## Technical Service Bulletin

**SUBJECT:** New AD Connecting Block Position

**Products Affected:** AD50-90(BB201XXX), AD72-00(BE201XXX)

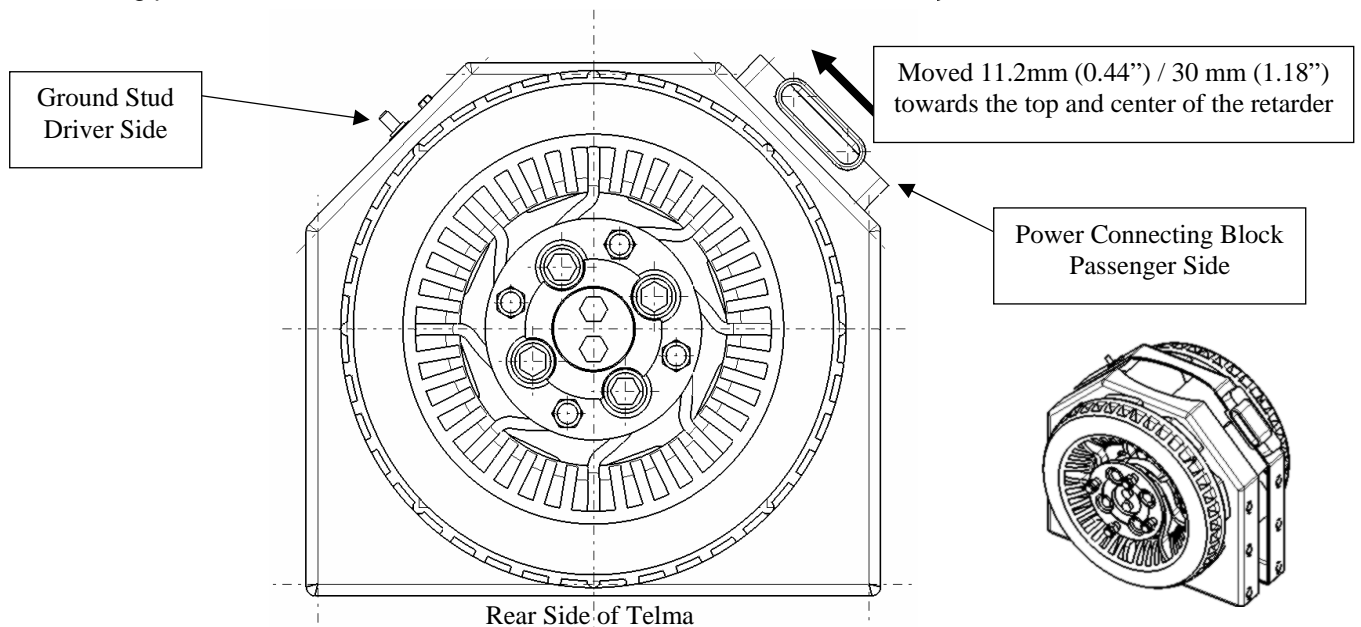
We are pleased to announce the modification of the AD connecting block location. The new location moves the connecting block away from the Telma side plate toward the top and center of the retarder.

The AD50-90 will have the connecting block moved 11.2mm (0.44 inches) towards the top and center of the retarder and the AD72-00 will have the connecting block moved 30mm (1.18 inches) towards the top and center of the retarder.

The two AD models affected will have connecting blocks that extend past the top of the Telma. The AD50-90 connecting block will extend 13.4mm (0.53 inches) above the top of the retarder, and 6mm (0.24 inches) above the top of the retarder for the AD72-00. This dimension will be taken into consideration by Telma engineering when issuing installation drawings so no special considerations will need to be taken by the installer or end user.

When ordering your Telma retarder use part number BB301158 to replace BB201158, use part number BE301152 to replace BE201152, and use BE301157 to replace BE201157.
